May 15, 2013
NRC3-13-0018

Subject: DTE Electric Company Response to NRC Request for Additional Information Letter No. 85

Response to RAI Letter No. 85
(eRAI Tracking No. 7077)

RAI Question No. 03.07.02-11

Figure 1: Geometry of Cylindrical Foundation Cross Section

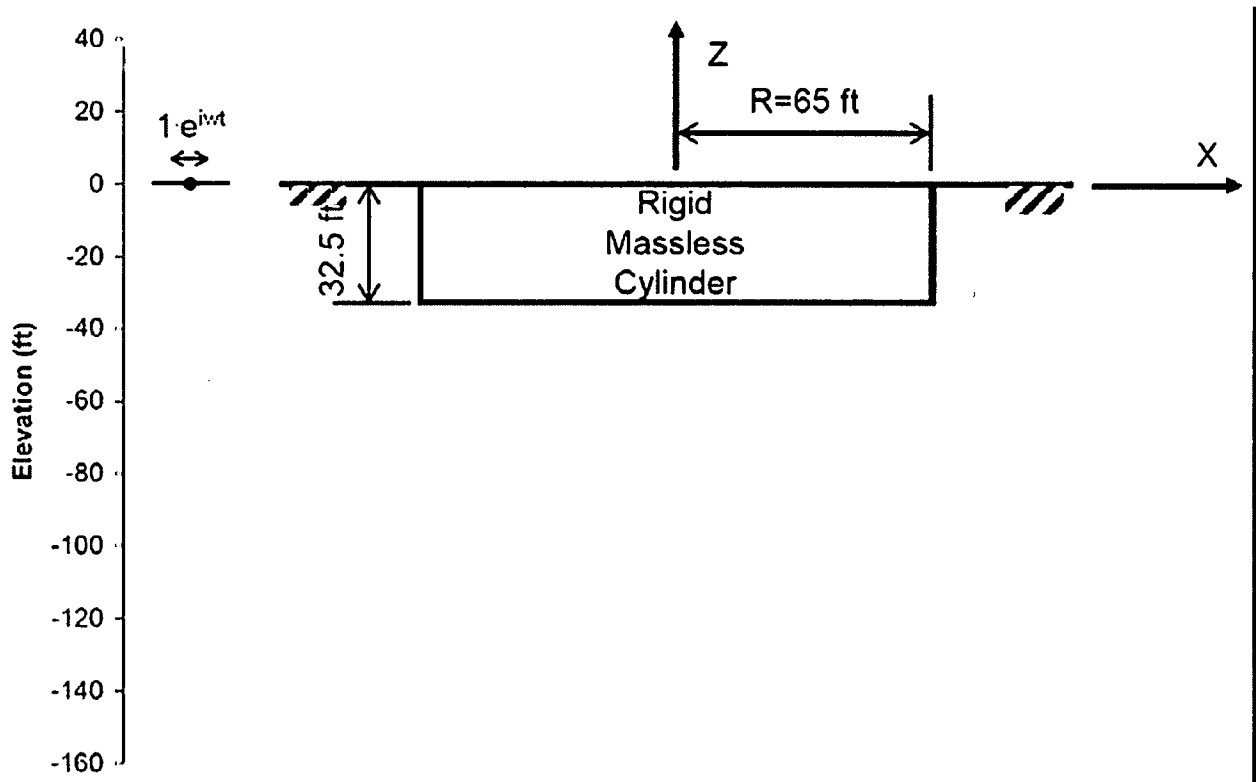
During the audit the staff determined that the test problems did not include validation for transfer functions or impedance functions, for frequencies above approximately 20 Hz up to 50 Hz for the Fermi 3 site.

In accordance with 10 CFR Part 50, Appendix S, to ensure that the seismic SSI analyses performed using SASSI2010 in support of the Fermi 3 Combined License application are adequate for the full frequency of interest at the Fermi 3 site, the applicant is requested to supplement the SASSI2010 V&V with additional test problems that address the issue identified above. This RAI also supplements RAI 03.07.02-9.

The geometry of the model is shown in Figure 1 and the isometric view of the finite element model of the rigid, massless structure is shown in Figure 2. Figure 2 also shows the excavated volume. The excavated soil and the rigid, massless structure are attached to independent internal node sets. On the perimeter of the excavation, the excavated soil and the rigid, massless structure are attached to the same nodes. As shown in Figure 2, only half of the foundation is modeled. Symmetry about the XZ plane is used to reduce the size of the problem. The foundation radius, R, is equal to 65 ft, and the embedment depth is 32.5 ft. This results in an embedment depth to foundation radius ratio of 0.5 (dimensionless parameter H). The parameter H = 0.5 is selected because Day's solution is provided for H = 0.5, H = 1.0, and H = 2.0. For the Fermi 3 RB/FB, the H value is 0.6 (embedment depth of about 65.6 ft and equivalent radius of about 108.4 ft.), which is close to Day's reported value of H = 0.5.
